Project	IEEE 802.16 Broadband Wireless Access Working Group < http://ieee802.org/16 >	
Title	Message definition to support MS network entry in centralized allocation model	
Date Submitted	2007-01-15	
Source(s)	<p>Shashikant Maheshwari, Yousuf Saifullah, Haihong Zheng Nokia</p> <p>Masato Okuda Fujitsu Laboratories LTD. Kamikodanaka 4-1-1, Nakahara-ku Kawasaki, Japan. 211-8588</p>	<p>Voice: 972 839 1878</p> <p>shashikant.maheshwari@nokia.com, Yousuf.saifullah@nokia.com, haihong.1.zheng@nokia.com</p> <p>voice: +81-44-754-2811 fax: +81-44-754-2786 mailto: okuda@jp.fujitsu.com</p>
Re:	This is in response to the call for proposal, 80216j-06_034.pdf, sent out by 802.16j TG.	
Abstract	This contribution proposes Message definition to support MS network entry procedures in non-transparent Relay Station systems with centralized allocation model.	
Purpose	To propose specification text to describe message signaling for MS network entry in non-transparent Relay Station systems with centralized allocation model.

Message definition to support MS network entry in centralized allocation model

Figure XX Extended MAC Signaling Header Type II Format

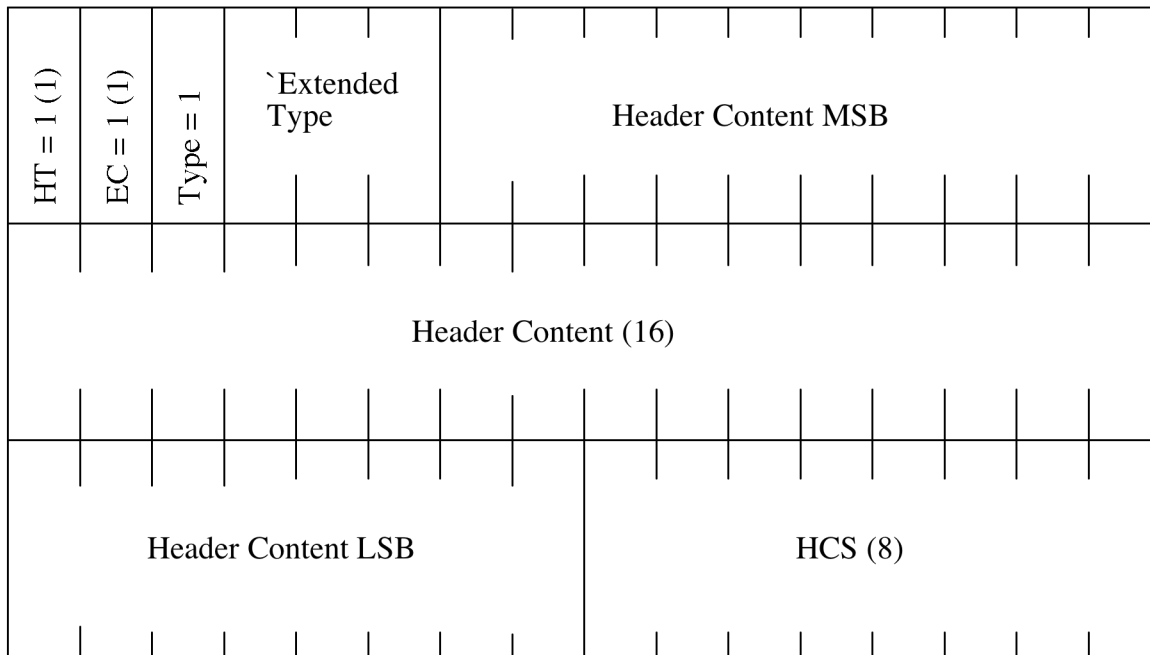
6.3.2.1.2.2.2 Extended MAC Signaling Header Type II

This type of MAC header is UL specific. There is no payload following the MAC header. The Extended MAC signaling header type II is illustrated in Figure XX. Table XX describes the encoding of the 3-bit extended type field following the type field.

Figure XX RS BR Header Format

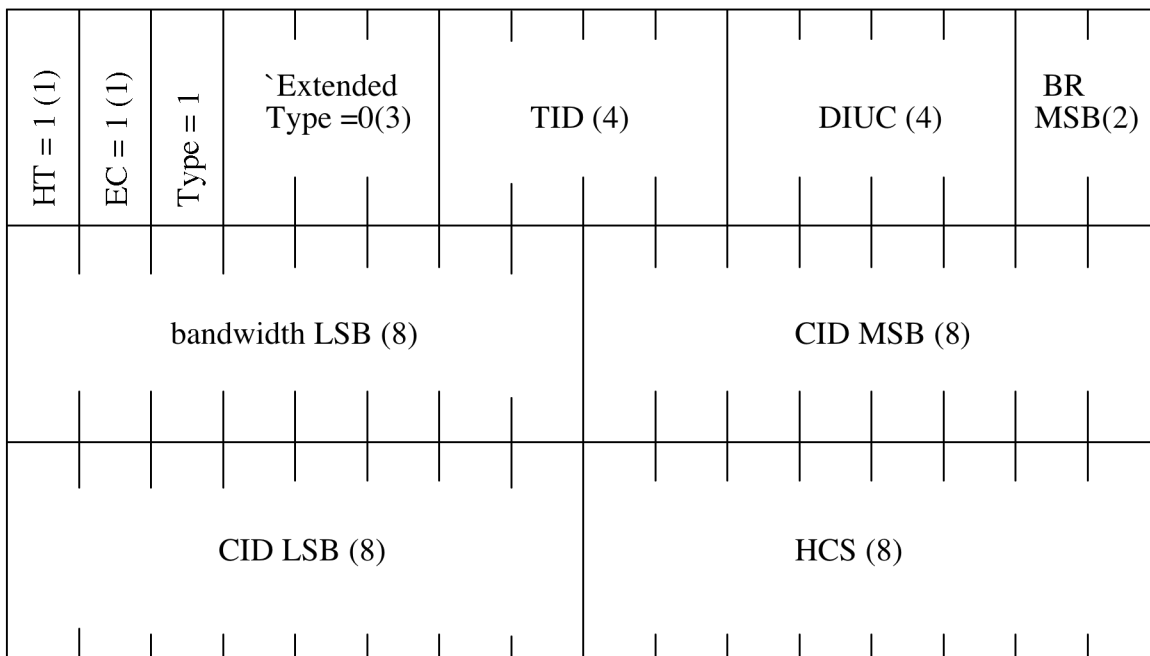
6.3.2.1.2.2.1 RS BW Header

RS BW request header is sent by the RS to request bandwidth for its access link from the MR-BS to send RNG_RSP. The RS Bandwidth request header is illustrated in Figure xx.
